Planning Commission Vote Report

Subject: Change of Zoning Vote Report

Petition: **P.Z. 12-2013 The Wedge (McGrath Plaza)**

RE: Energy Marketing #709 – P.Z. 12-2013
Preliminary Development Plan/Change in Zoning “Wedge Property”
Pickett, Ray & Silver, Inc. Project No. 09056.EMKT.00R

Revised Preliminary Plan

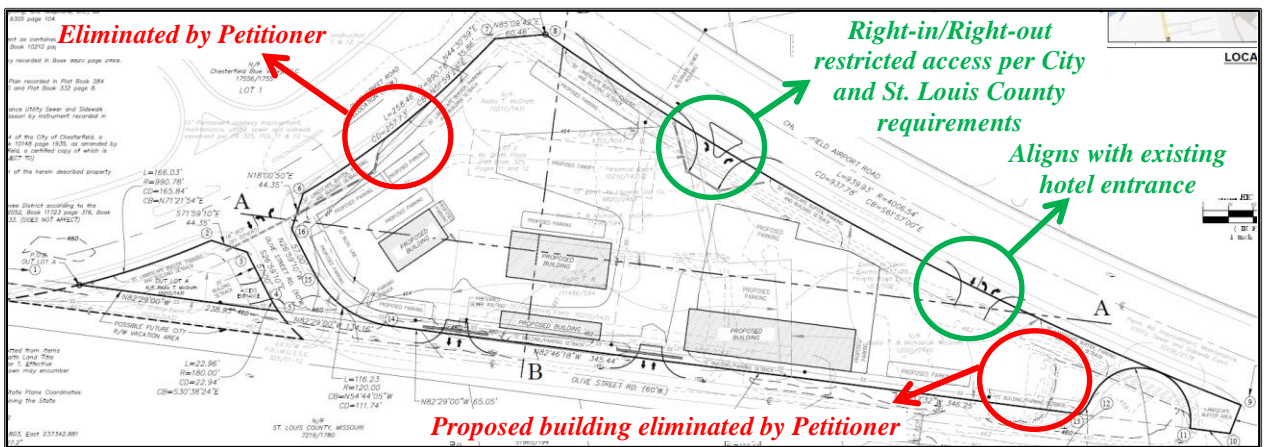
- Concerns regarding the number and location of access points off of Olive Street and Chesterfield Airport Roads.

- The excerpt from the revised Preliminary Plan shows the substantial revisions that the Petitioner has made on the Preliminary Plan. The property frontage on the relocated Olive Street Road equates to approximately 360 feet. This frontage is located between the remaining portion of Olive Street Road and Chesterfield Airport Road and did not provide adequate spacing for the proposed access onto relocated Olive Street Road. **As such, per Staff recommendation, the Petitioner eliminated this access, as shown below.**

Note that a deceleration lane and geometric channelization has been added to the configuration of the westernmost access point along Chesterfield Airport Road. This will allow for safe right-in/right-out only turning movements and will mitigate any negative effects on traffic flow along Chesterfield Airport Road. The two access points along old Olive Street Road meet drive spacing requirements for a local street and will improve internal site circulation.

Following the Issues Meeting and subsequent meetings with Staff, the Petitioner provided an amended Preliminary Plan which made revisions to the site to address issues identified at the Public Hearing and by Staff. This revised Preliminary Plan maintains the landscape buffer along Chesterfield Airport Road and the relocated portion of Olive Street Road to the thirty (30) foot minimum requirement for commercial districts with frontage along arterial streets. In addition to this required buffer, the Petitioner revised the plan to include a fifteen (15) foot parking and building setback along Old Olive Street Road, which is no longer classified as an arterial street and is therefore not subject to any buffering requirement by the Municipal Code. Despite the lack of required buffering along this frontage, the addition of a building and parking setback alleviates Staff’s concern of parking fields commencing at the property line.

Additionally, the Petitioner eliminated the small building in the far eastern corner of the site. In eliminating this building, the Petitioner has significantly reduced the previously proposed intensity of the site and provided a plan that better suits this highly irregularly shaped property. Further, it is Staff’s opinion that the elimination of this building will facilitate improved internal circulation and provide more area for the Petitioner to meet City Code requirements, including parking, open space, and landscaping requirements, outright without requesting several modifications from Code during the Site Plan review phase.

Finally, as requested by Staff and the Planning Commission, the Petitioner eliminated the access point off of relocated Olive Street Road. The remaining access points have been evaluated by Staff and, given the unique shape of this property, the accesses as shown have found to be appropriate for a development of this size and intensity. Staff maintains that the elimination of the relocated Olive Street Road access will allow for safe access into the site as well as improved internal site circulation. The Attachment “A” prepared by Staff reflects what is shown on the Preliminary Plan and satisfies Staff’s concerns.

Preliminary Development Plan

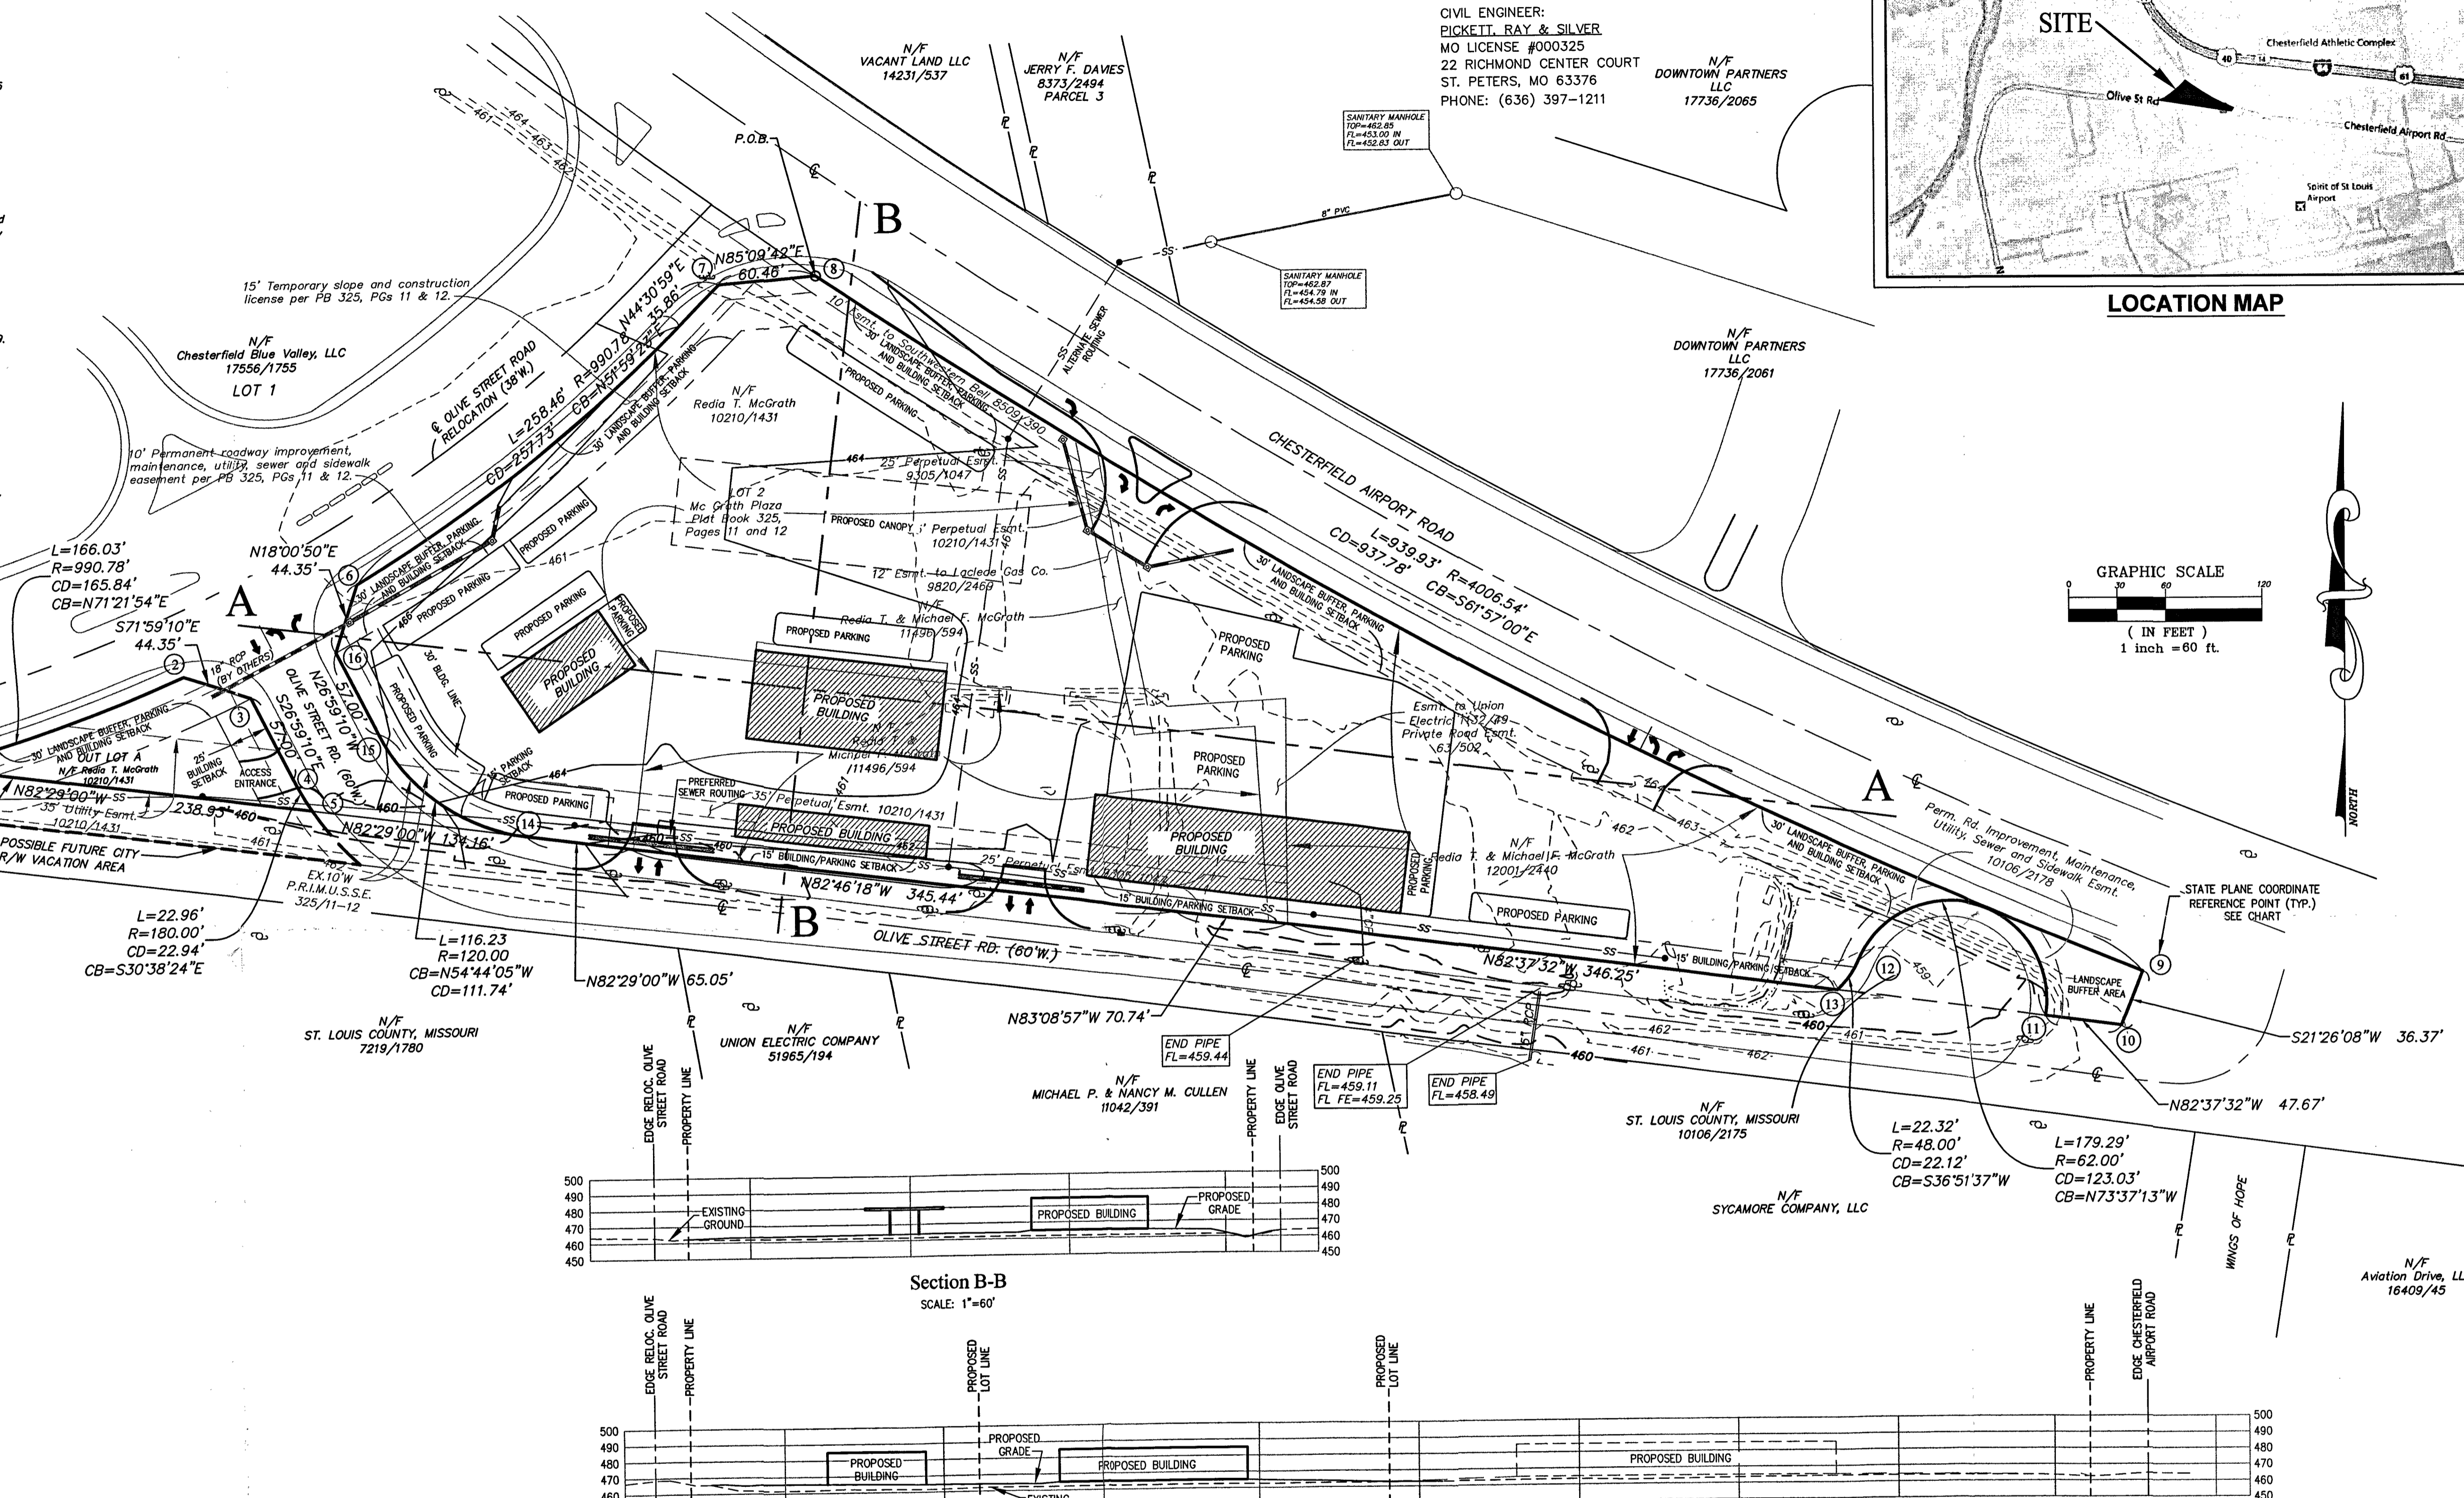
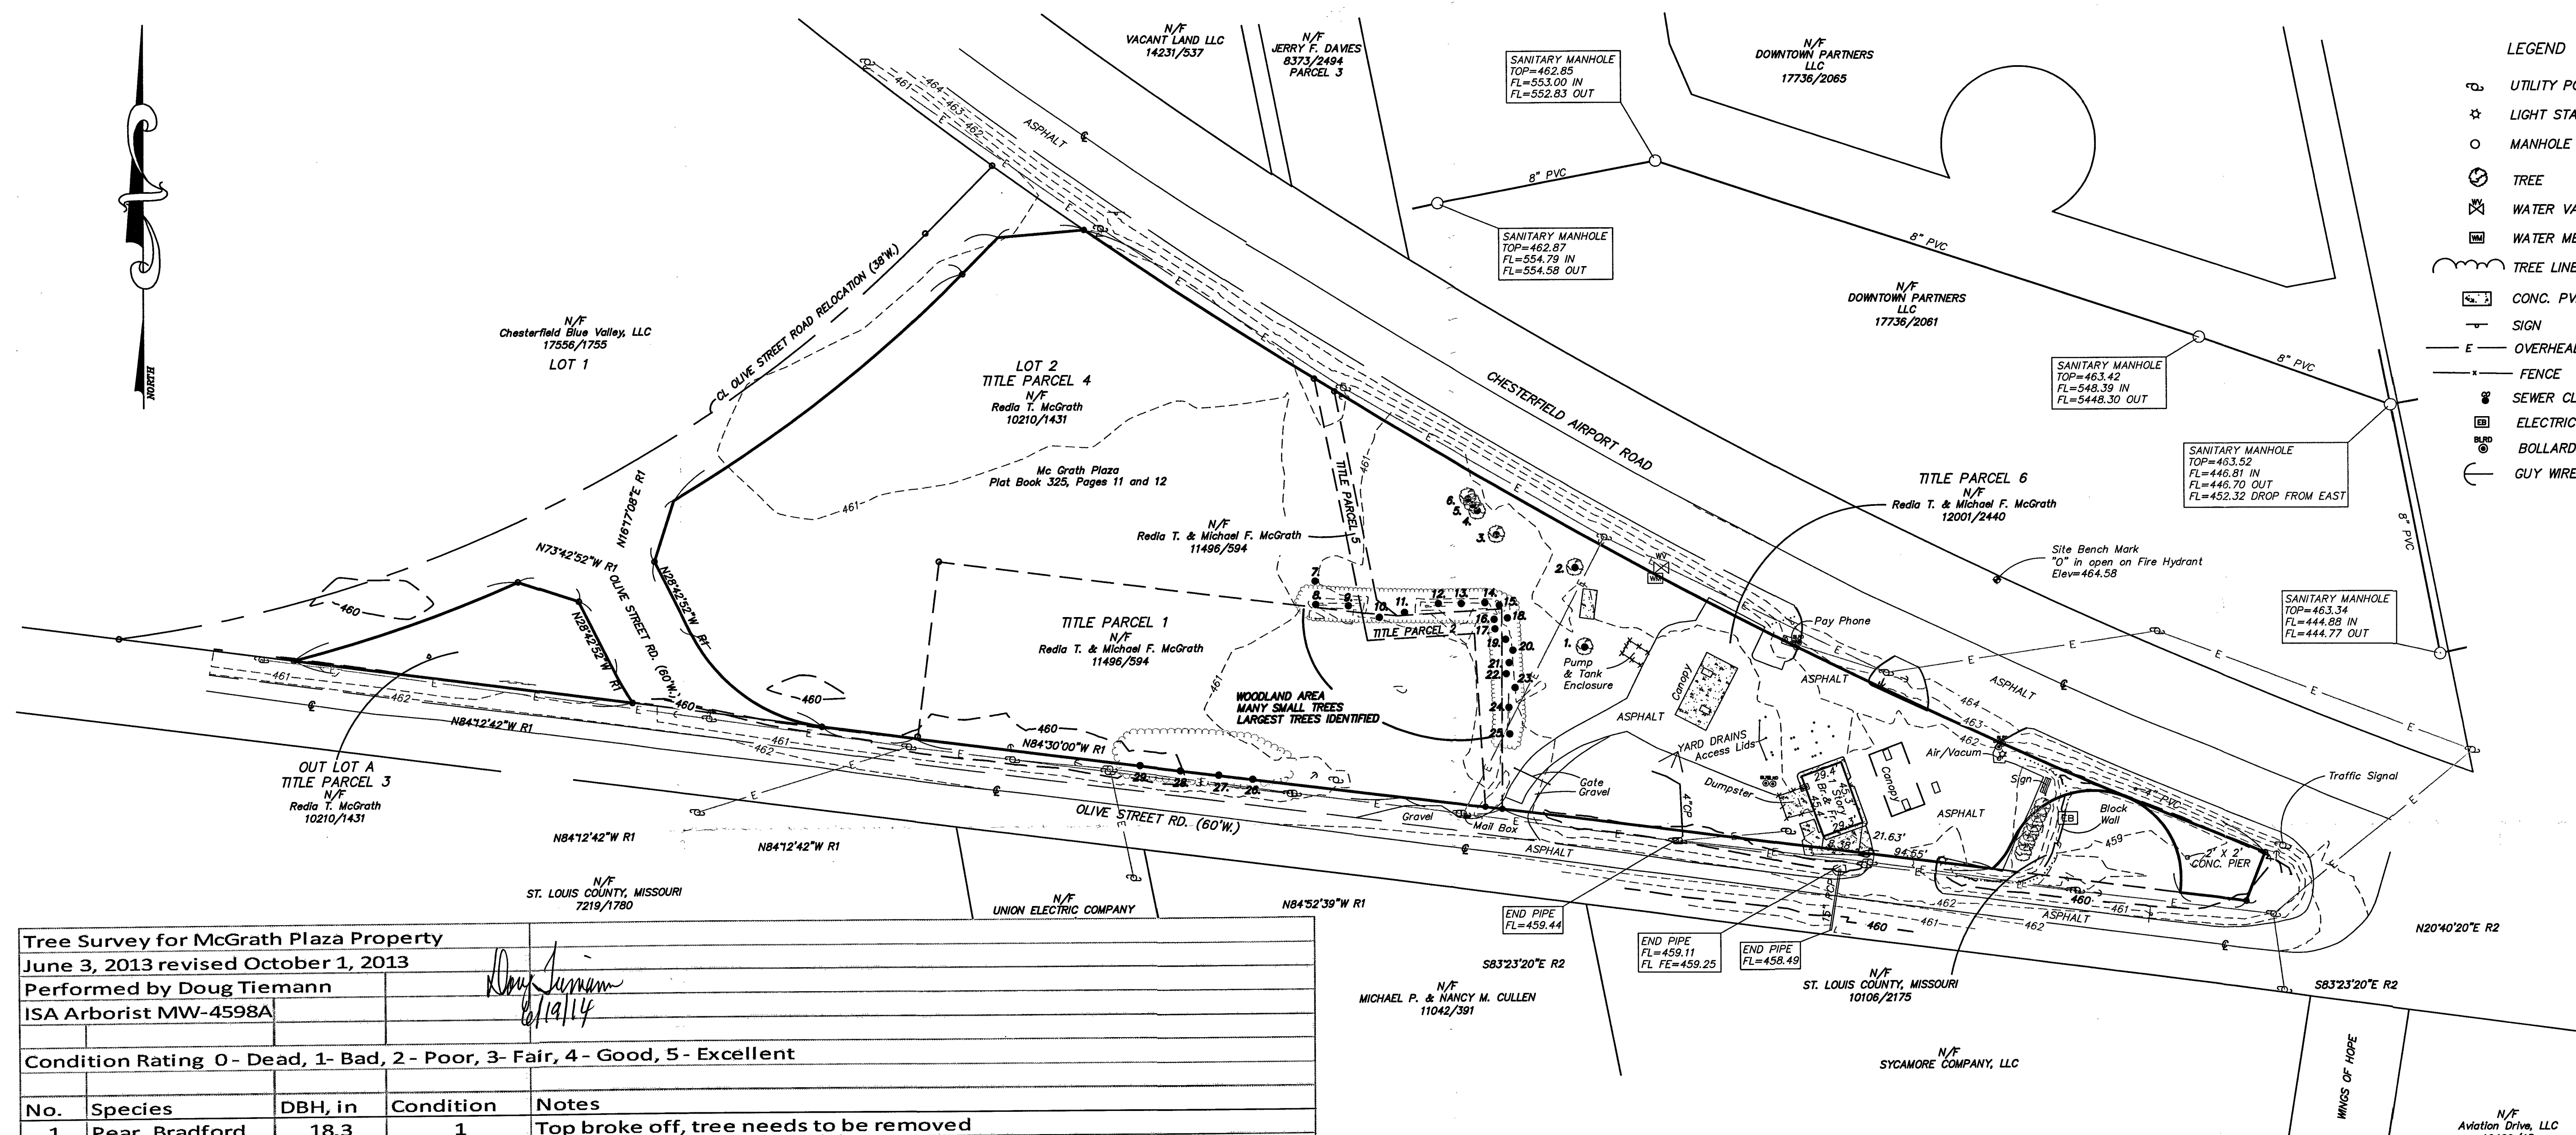
1. *Address concerns with the number and location and access points off of Olive Street and Chesterfield Airport Roads. Note that compliance with Chapter 26 Article III Driveway Access Location and Design Standards of the Municipal Code is required.*

2. *Address the concerns with the number, type, and intensity of the uses requested.*

3. *Address concerns with the parking and building setbacks and landscape buffers as shown the Preliminary Plan.*

4. *Concerns about specific items and areas:*

a. *FAR and parking located adjacent to that specific building.*

b. *Loading space requirements.*

c. *Each proposed building will require a separate dumpster with screening.*

d. *Sidewalks will be required both along the Chesterfield Airport Road and relocated Olive Street Road and internal to the site to allow for safe pedestrian access to each building within the site.*

e. *Parking areas will be required to provide landscape islands and trees as required by Tree Preservation and Landscape Manual requirements.*

f. *On-site drainage structure (such as bio-retention areas) will be required.*

g. *Access Management requirements, including throat depth requirements, must be met.*

The PDP has been revised, the access along relocated Olive Street Road has been removed. A traffic impact study has been completed by BLA & Associates. The recommendations from the traffic study have been incorporated into the preliminary development plan. A right-in/right-out is proposed on Chesterfield Airport Road at the western end of the development and a full access is proposed on Chesterfield Airport Road across from the Comfort Inn and Suites. Two access points are proposed on old Olive Street Road along the southern edge of the property.

The list of uses requested on the site has been reduced to the following forty-eight (48) uses.

The plan shows a 30-foot wide landscape buffer, parking and building setback along the entire portion of Chesterfield Airport Road and Relocated Olive Street Road as required.

The proposed Preliminary Development Plan meets the requirements for 35% open space, parking for the proposed uses can be met as shown on the plan. The proposed PDP has parking for approximately 140 spaces and the minimum spaces required by "typical" proposed uses calculates to approximately 110 spaces. Therefore, parking can be achieved on the site and it is likely that some of the areas shown as parking will be converted to green space.

The floor area ratio has been analyzed for the site as proposed in the site development plan and the FAR density (including pump canopy) is 0.151 which is well below the required maximum of 0.55. The PDP meets the parking requirements and shows the parking located adjacent to the specific building

The PDP can meet the required number of loading spaces. Loading spaces are available adjacent to the Retail space and can also be placed behind the proposed car wash.

Each building has a designated separate dumpster. Screening will be provided.

Sidewalks will be provided along both Chesterfield Airport Road and relocated Olive Street Road along with internal pedestrian access to each building.

Landscape islands are shown in parking areas and will be provided as required by the Tree Preservation and Landscape Manual requirements.

Bio-retention areas will be provide and are shown on the PDP.

Access management requirements meet the guidelines of the TIS analysis and throat depth requirements will be provided.
